RS-06-063

**Quad Cities Nuclear Power Station, Units 1 and 2
Renewed Facility Operating License Nos. DPR-29 and DPR-30
NRC Docket Nos. 50-254 and 50-265**

**Subject: Additional Information Regarding Quad Cities Unit 2 Steam Dryer
Inspection, Start-up and Power Ascension Plan**

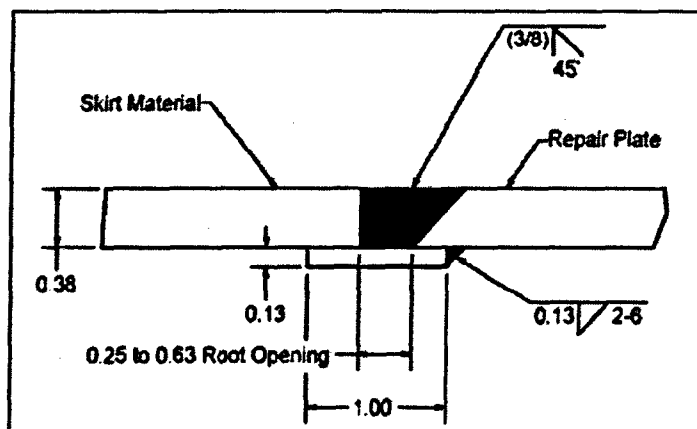
Discuss the potential for loose parts resulting from the failure of the backing bar.

Repairs to the QCNPS Unit 2 steam dryer skirt and skirt base ring were made with full penetration welds. In consideration of diver safety and dose these welds were made from the outside of the dryer skirt. To provide for underwater welding from one side only it was necessary to use a backing strip at the weld root. The backing strip was not removed after welding. The backing strip has a 1-inch wide by 0.13-inch thick cross-section. The below figure shows a cross-section view through the completed skirt repair weld. A cross-section through the base ring would be similar except that the base ring and base ring materials are 1-inch thick. In the completed weld, the backing strip surface exposed to the root opening is fused and becomes part of the weld. Prior to welding of the joint, one edge of the backing strip is attached to the back side of the repair plate using a stitch weld technique (0.13 inch fillet welds, 2 inches in length, with a 6 inch pitch). The backing strip material used is compatible with the base metals. Also, a qualified welding procedure and qualified welders were used. Separate backing ring welds have been used in constructing many of the operating plant BWR steam dryers.

Based on an acceptable weld joint configuration; a continuous backing strip being used; the backing strip being compatible with the base metals; the use of a qualified welding procedure

and qualified welders; and previous operating plant experience it is extremely unlikely that these repair weld backing strips will ever come loose.
